**FIELD REPORT – LYNNWOOD RECREATION CENTER – FIELD REPORT**  
REPORT #06

Job No. 10-100622B1

**Location(s) of Work:** Natatorium roof, HVAC Replacement.

*Overview of the Natatorium Roof taken facing south.*

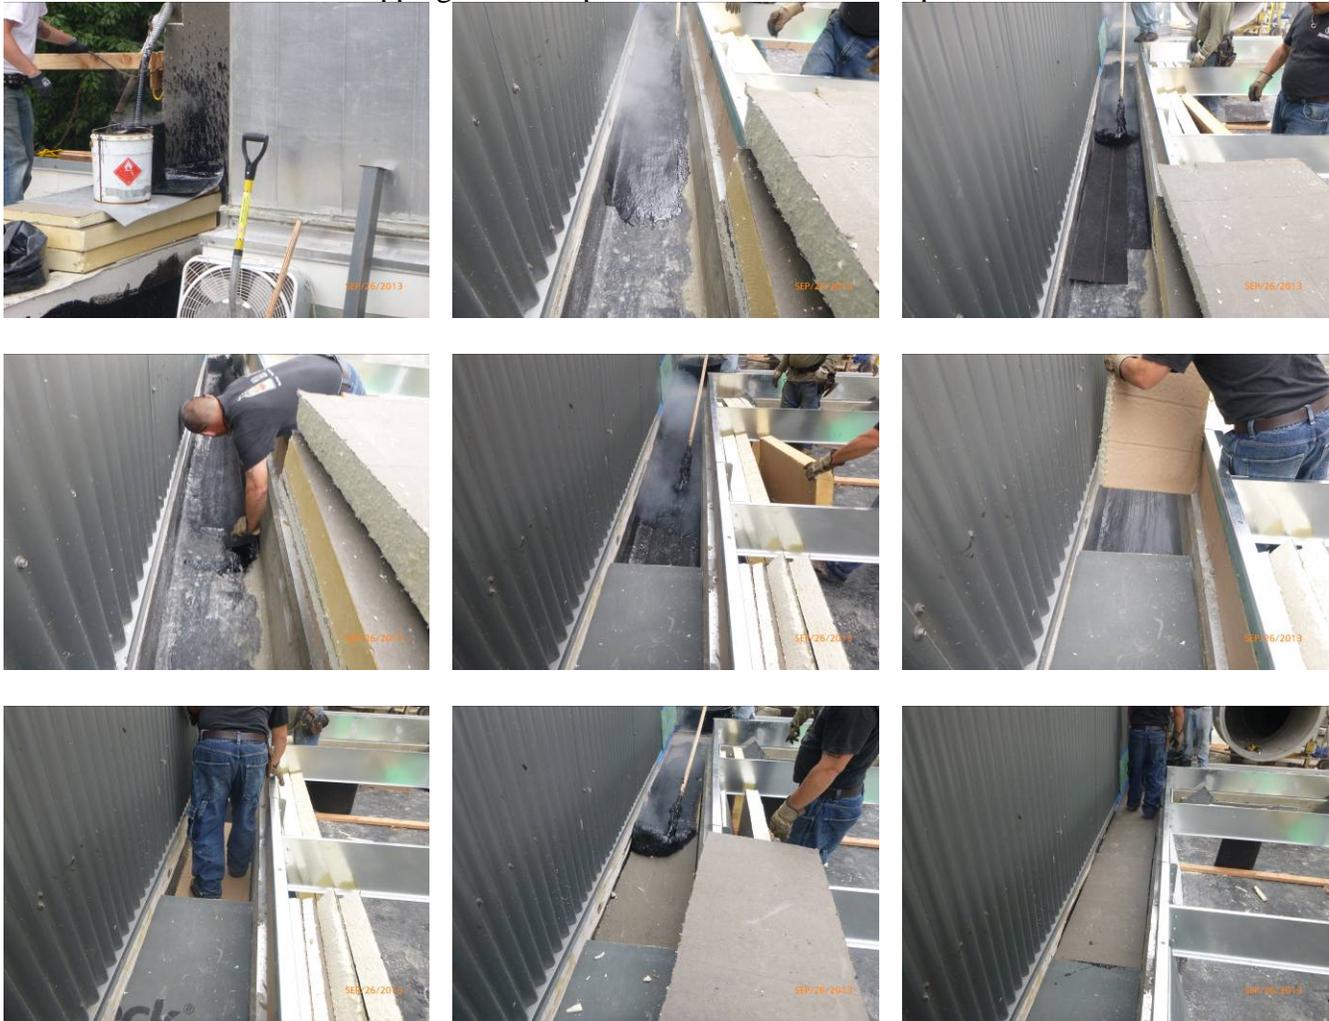
- 6.1 Delta Construction is installing unistrut supports for the new HVAC ductwork at the Natatorium Roof. Queen City Roofing is installing tapered insulation and coverboard (set in hot moppings of Type IV asphalt) under the TPO baseflashing at the east HVAC curb.

**CASC Roof Progress Plan / Locator Map:**

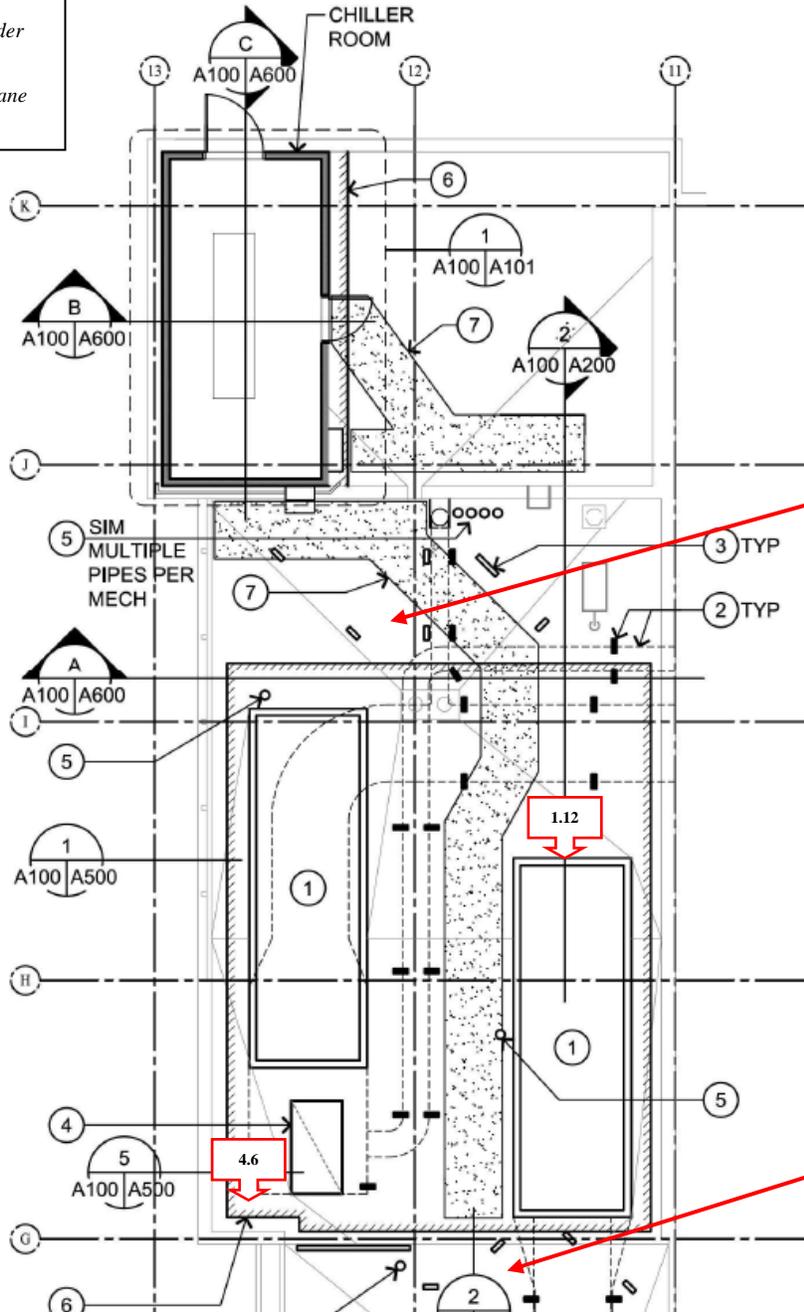
North of this line (approx.) the remainder of the Natatorium roof is wet and damaged as an existing condition.

Recommend verifying the presence of a vapor retarder layer over the deck south of Natatorium Roof.
